## ADDENDUM #2

Reference: Testing & Assessment Center Remodel – Construction Trades Bldg.  
Salt Lake Community College – Redwood Road Campus – Salt Lake City, Utah  
DFCM Project No. 07033660

**Addendum No. 01**

Project: Testing & Assessment Center Remodel  
Address: Redwood Campus  
City, State: Salt Lake City, Utah  
Owner: DFCM

WALL TO MULLION DETAIL

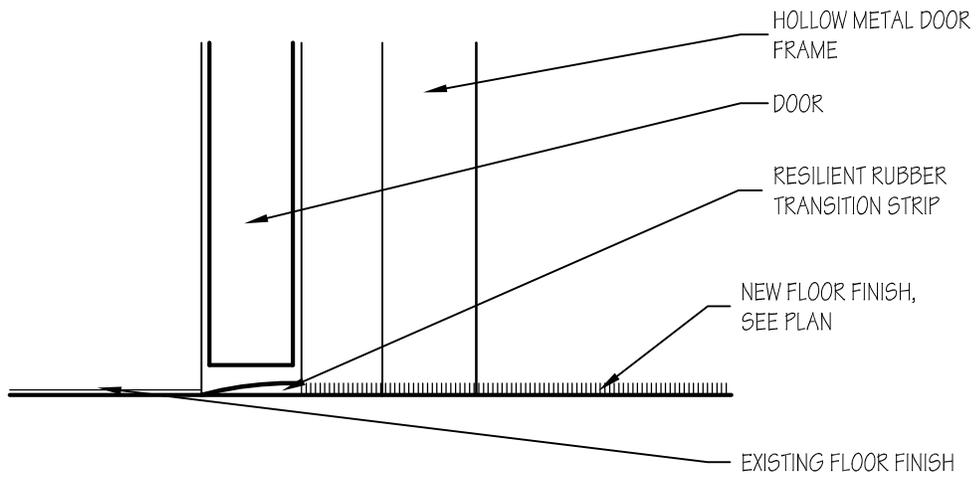
- 1 -15 AE601 Detail A4 DOOR SCHEDULE: Change door 010B UL Label to 20 minutes. Change doors 010A and 033 threshold detail to C1/AE601.
- 1 -16 AE601 Add the attached detail B1/AE601, wall to window mullion detail. Detail applies to two new walls.

## PARTIAL POWER DEMOLITION PLAN

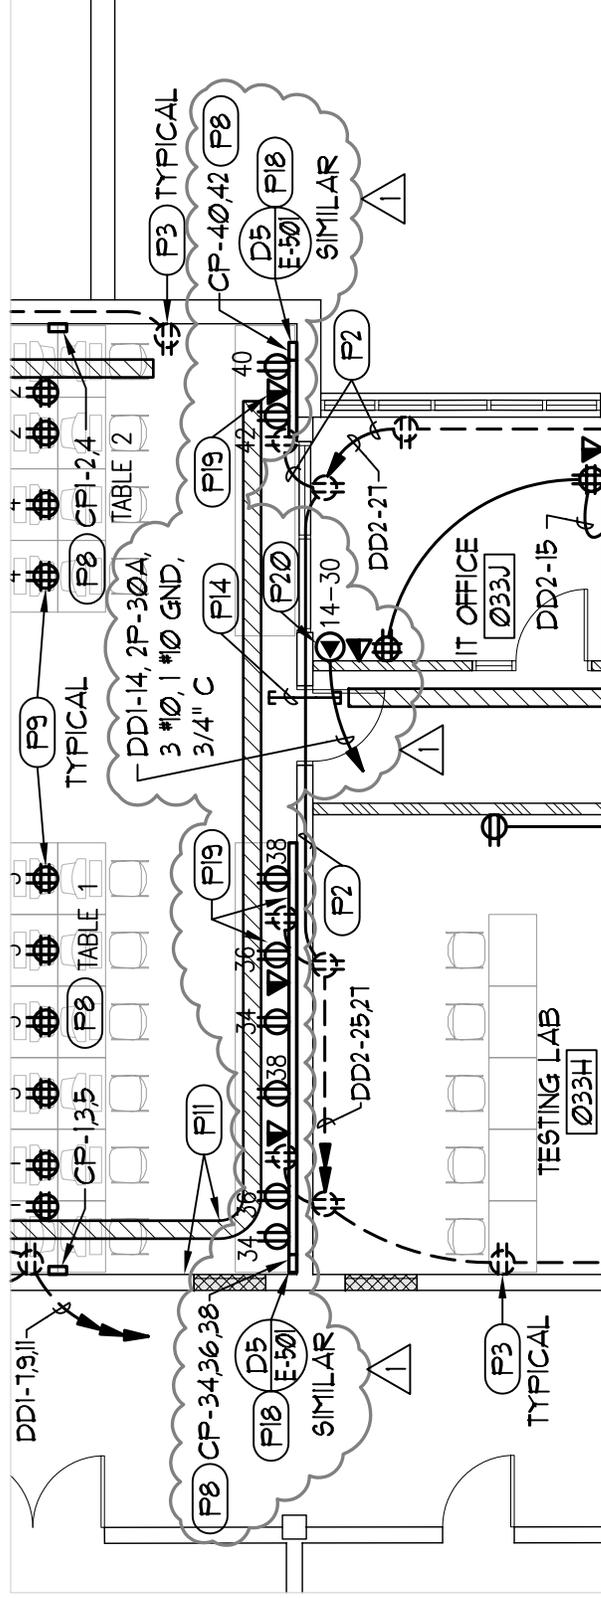
1. REMOVE ELECTRICAL CIRCUIT FOR CABINET HEATER.
  - A. Remove existing circuit to existing cabinet heater to be removed at north end of Corridor 001 and reconnect circuit to existing cabinet heater in stairway as shown on attached Partial Power Demolition Plan, Sheet ED101a.

- ① (P11) EXISTING CABINET HEATER TO BE REMOVED. DISCONNECT AND REMOVE ALL EXISTING WIRING. ABANDON EXISTING UNDERGROUND CONDUIT IN PLACE.
- (P12) EXISTING CABINET HEATER IN STAIRWAY TO REMAIN. PROVIDE NEW BRANCH CIRCUIT ABOVE EXISTING CEILING AS INDICATED.

**A1 PARTIAL POWER PLAN**

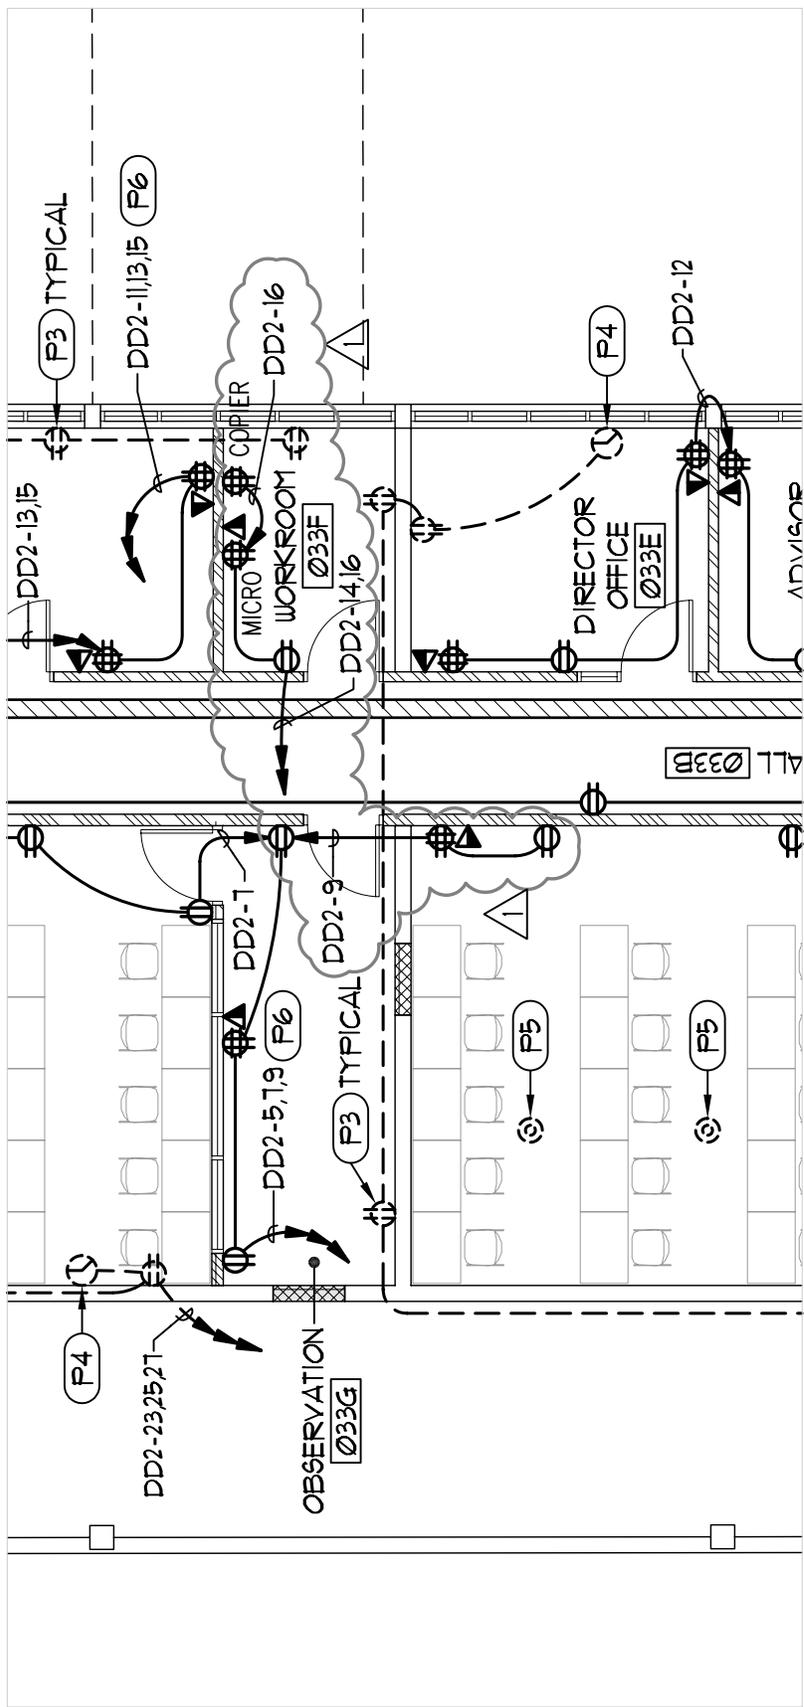
2. ADD MULTI-OUTLET ASSEMBLIES IN COMPUTER TESTING LAB 010.
  - A. Add surface raceway systems and surface multi-outlet assemblies with receptacles, circuits, and tele/data outlets on south wall of Computer Testing Lab 010 for printers as shown on attached Partial Power Plan, Sheet E-101a.

- A. Provide new NEMA 14-30 Receptacle and branch circuit for Owner furnished UPS in IT Office 033J as shown on attached Partial Power Plan, Sheet E-101a. Verify receptacle configuration with Owner prior to ordering.

- (P18)** PROVIDE NEW SURFACE RACEWAY SYSTEM FROM CEILING TO NEW SURFACE MULTI-OUTLET ASSEMBLY AT PRINTER TABLES FOR POWER AND DATA TO PRINTERS. SIMILAR TO DETAIL D5/E-501 EXCEPT CONNECT TO MULTI-OUTLET ASSEMBLY.
- (P19)** PROVIDE WIREMOLD 5400 SERIES, OR EQUAL, SURFACE NON-METALLIC MULTI-OUTLET ASSEMBLY ON WALL 44"± ABOVE FINISHED FLOOR TO CENTER OF RACEWAY. PROVIDE DEVICE BRACKETS, FACEPLATES, ETC., NECESSARY FOR INSTALLATION OF RECEPTACLES AND TELE/DATA OUTLETS INDICATED.
- (P20)** PROVIDE RECEPTACLE FOR OWNER FURNISHED UPS. FIELD VERIFY EXACT LOCATION AND REQUIREMENTS WITH ARCHITECT AND/OR OWNER.
